HUB Cycling Decision Matrix for Preliminary Kitsilano Beach Park Cycle Path Routing

January 29, 2018

Seaside Greenway: Kitsilano Beach Park

Design Decision Matrix

DRAFT: Kitsilano Beach Park Bike Path - Options Discussed

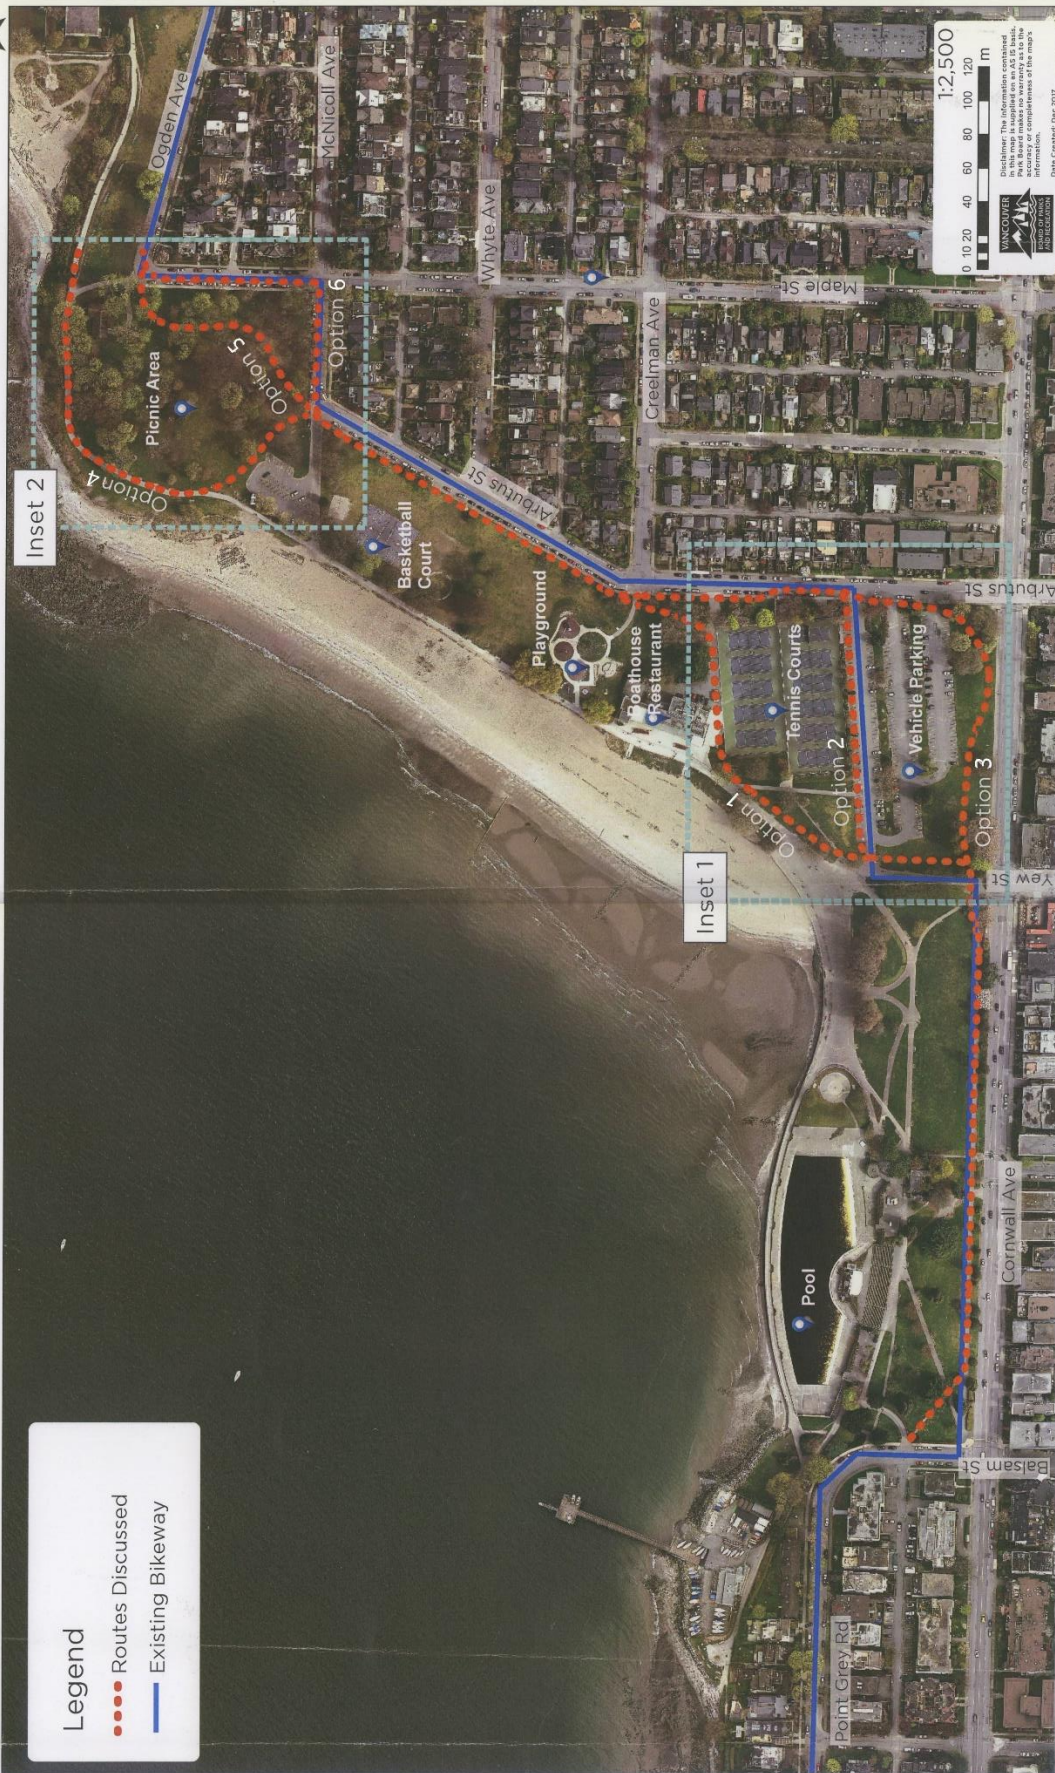
Pedestrian Conflict Potential: We left the “High” conflict scores for Options 1 and 2, but reduced the score for Option 3 to “Medium” due to the significant pedestrian traffic crossing at Yew, the Arbutus/Cornwall corner, and along Arbutus itself.

Vehicle Conflict Potential: We completely disagreed with the Park Board assessment of Options 2 and 3. Option 2, the south-of-tennis-court route only crosses traffic at the Boathouse access road. That is a very low conflict potential. On the other hand, Option 3 is required to cross anywhere from one to three beach parking lot accesses as well as the Boathouse access road. That is a high conflict potential, but we left it scored as “medium”.

Park-like User Experience: HUB Cycling disagreed with the Park Board assessment, particularly concerning

Options 2 and 3. Option 1 and Option 2 have similar park-like experiences, with the exception of the final routing around the tennis courts (north-side vs south-side). The scoring reflects this. On the other hand, Option 3 keeps the people on bicycles completely out of the beach park, and is not a park-like experience at all.

Intuitive Wayfinding: HUB Cycling interpreted this decision factor as “how easy is it to tell you’re going where you want to go”. Given most park users want to go to the park, this means that if the path is going into the park, it’s intuitively going where you want. Consequently, high scores were awarded to Options 1 and 2 which do just that. Option 3, however, does not take you into the park, nor does it seem to go along the “seawall”, and so scores low on this factor.

HUB Cycling favours Option 1, followed by Option 2 in the Southern Parking Lot area. The difference in assessing the decision factors between HUB Cycling and the Park Board are entirely in the scoring of the Pedestrian Conflict Potential, Vehicle Conflict Potential, Park-like User Experience, and Intuitive Wayfinding.

HUB Cycling agrees with the Park Board in favouring Option 5 in the Northern Greenspace area. Although Option 6 scores as highly as Option 4 in this decision matrix, the on-street route is very undesirable.
